Groundwater and Wastewater Services File Imaging Project
May 2007
Barcode Font = IDAutomationHC39M

6787 County Permit Review Worksheet

GWS Septic System Design Review

RE: Request for an Improvement Permit for Lot 59 at The Retreat at Latta Plantation off of Sample Road.
MCHD File #6797B

Scale: 1 inch equals 50 feet	S&ME	Faison-Sample Road, LLC	FIGURE
Drawn by: JBP		Lot 59	
Reviewed by: Jeremy P. Michelone, RS		Mecklenburg County, NC	1
Date: March, 2007	ENVIRONMENTAL SERVICES · ENGINEERING · TESTING	S&ME Project #1588-05-091

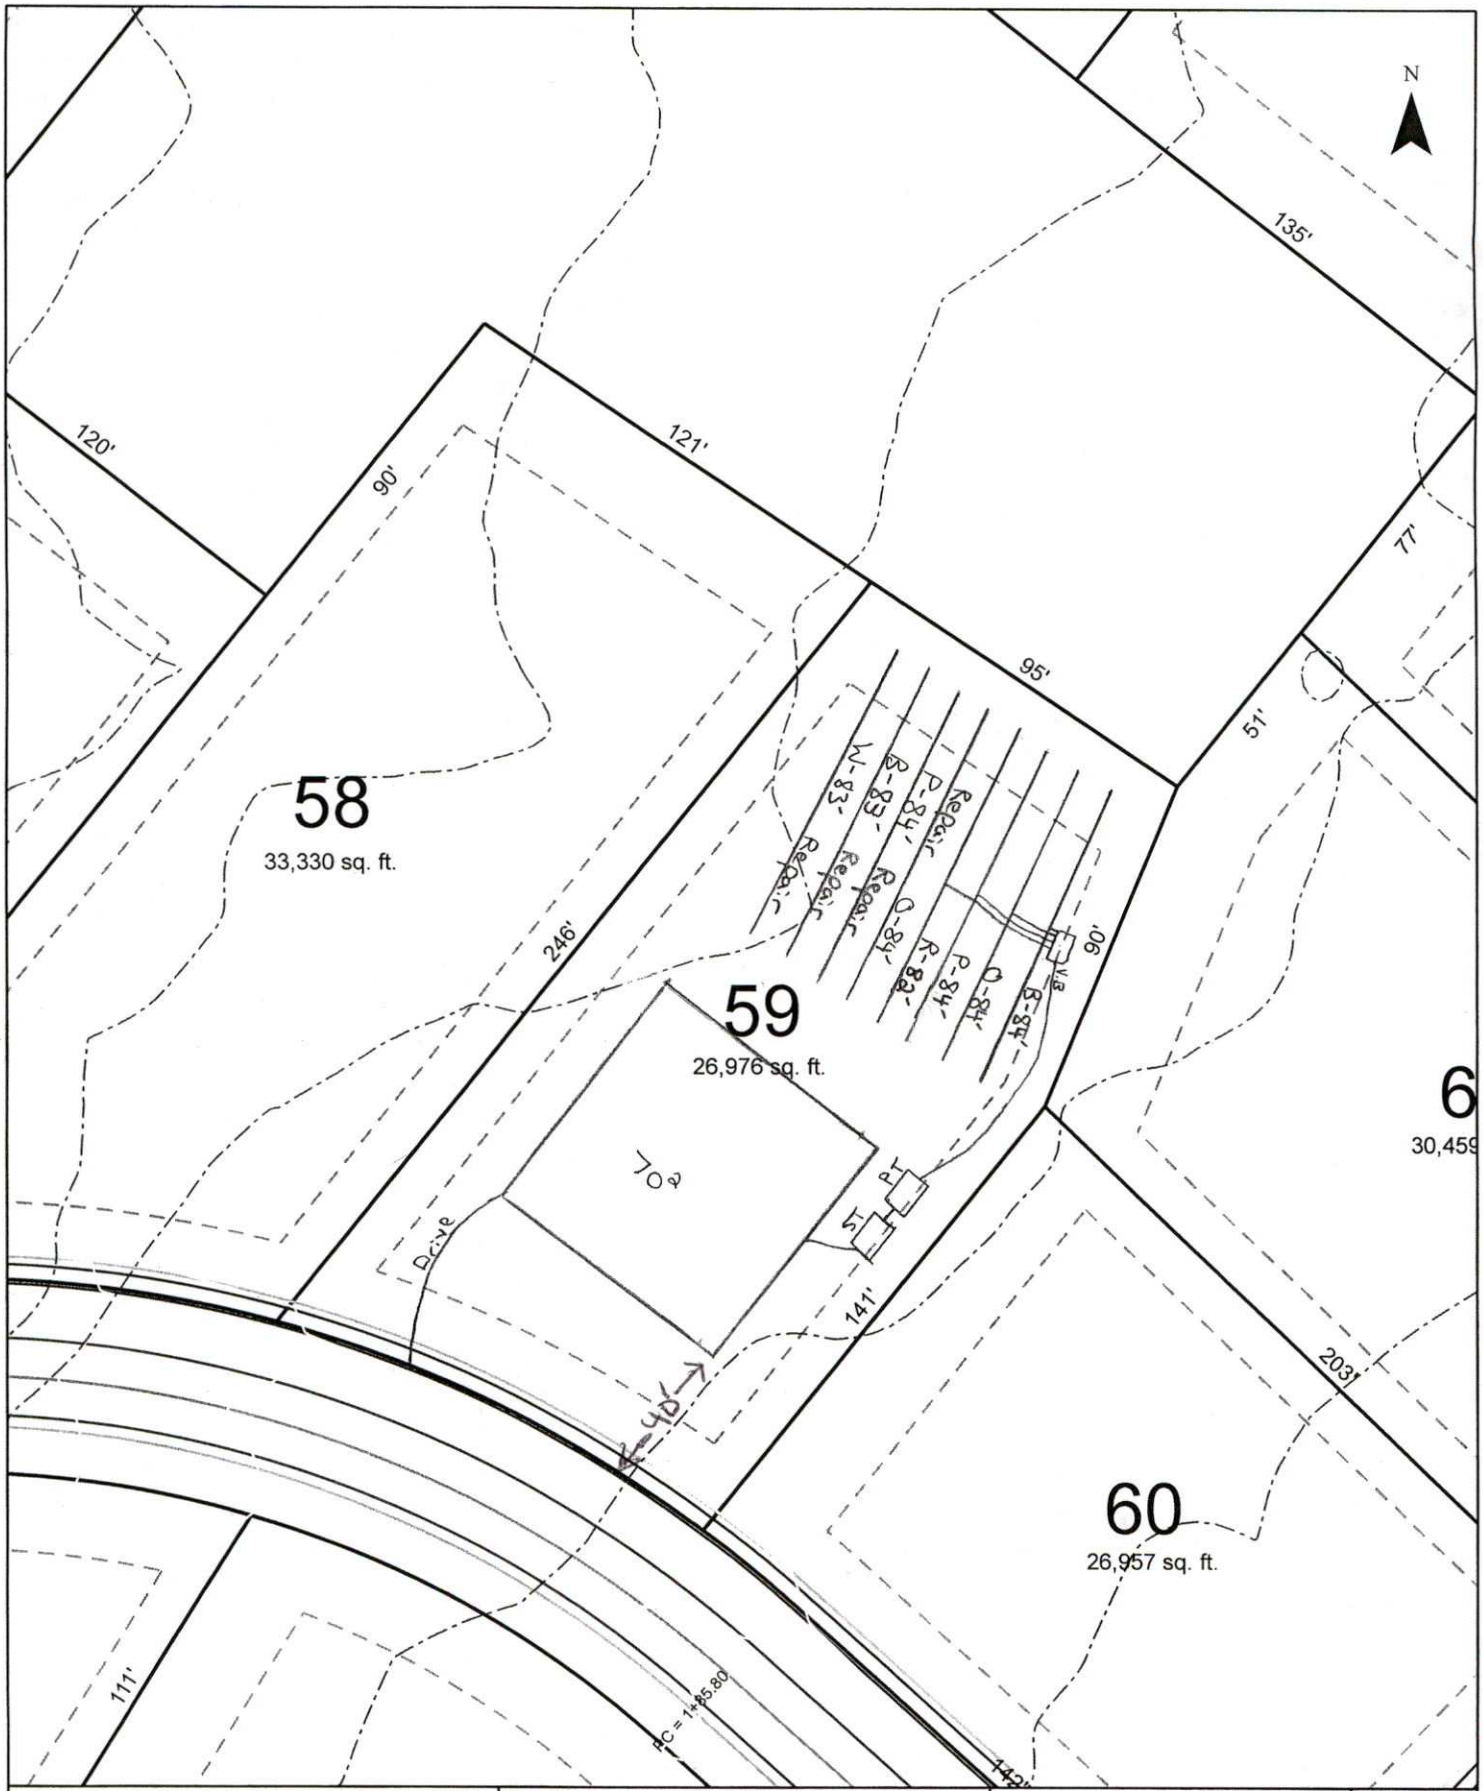
Approved	Disapproved
GWS File #: 6797B		
Design Review: TCT 4-9-07	☒	☐
Field Review: 4/5/07	☒	☐

Please review the attached system sketch and design specifications for the Improvement Permit. Any additions or revisions you feel are necessary can be made on the Improvement Permit. Please call if you have questions or comments.

1. Install system using 3 ft. wide trenches.								
2. Install drainlines on 9 ft. centers, level, and on contour.

3. System design requires effluent pump for distribution.								
4. 100% Repair area is required.
